AMD-K6[®]-2

Processor Revision Guide

Model 8

Publication # 21641 Rev: D Amendment/ 0 Issue Date: August 1998
--

Figure 1. AMD-K6[®]-2 Processor Assertion of HLDA Due to Simultaneous \overline{BOFF} /HOLD Assertion

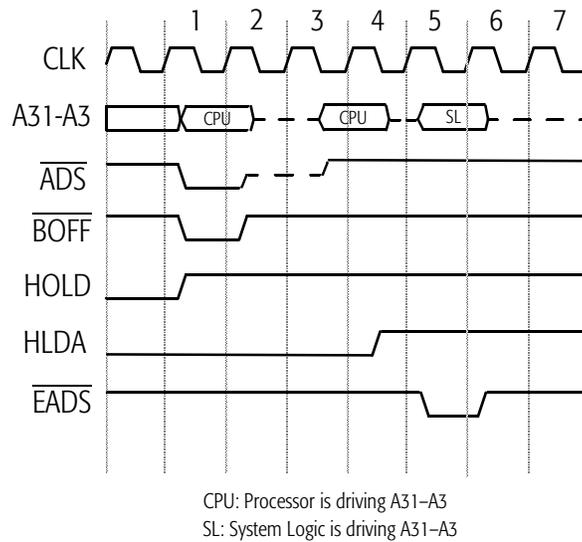
Normal Specified Operation. If $\overline{\text{BOFF}}$ and HOLD are sampled asserted on the same clock edge that negates $\overline{\text{ADS}}$, the processor asserts HLDA one clock edge after HOLD is sampled asserted.

Non-conformance. If $\overline{\text{BOFF}}$ and HOLD are sampled asserted on the same clock edge that negates $\overline{\text{ADS}}$, the processor asserts HLDA two clock edges after HOLD is sampled asserted.

Potential Effect on System. There are three potential effects of this erratum to consider:

- If the system logic asserts $\overline{\text{BOFF}}$ for a duration of one clock, anticipates the assertion of HLDA in clock 3 (see Figure 1)—which is the normal specified operation—and drives the address bus and $\overline{\text{EADS}}$ for an inquire cycle in clock 3, then the processor will not sample $\overline{\text{EADS}}$ asserted. In addition, address bus contention will occur in clock 3.

- If the system logic asserts $\overline{\text{BOFF}}$ for a duration of two clocks, anticipates the assertion of HLDA in clock 3, and drives the address bus and $\overline{\text{EADS}}$ for an inquire cycle in clock 3, then the processor will not sample $\overline{\text{EADS}}$ asserted. (No address bus contention occurs in this case.)

- If the system logic asserts $\overline{\text{BOFF}}$ for a duration of one clock, anticipates the assertion of HLDA in clock 3, and drives the address bus and $\overline{\text{EADS}}$ for an inquire cycle in clock 4, then address bus contention may occur in clock 4. (The processor will sample $\overline{\text{EADS}}$ asserted in this case.)

If the processor does not sample $\overline{\text{EADS}}$ asserted during an inquire cycle, cache/memory incoherency will occur. Address bus contention can affect the reliability of the processor and the system logic.

Suggested Workaround. The system logic must sample the assertion of HLDA before asserting $\overline{\text{EADS}}$ and driving the address bus for an inquire cycle—as shown in clock 5 of Figure 1.

Resolution Status. AMD has determined that all Socket7 and Super7[™] chipsets operate as described in the aforementioned suggested workaround. Therefore, AMD has decided to defer the resolution of this erratum until deemed necessary.
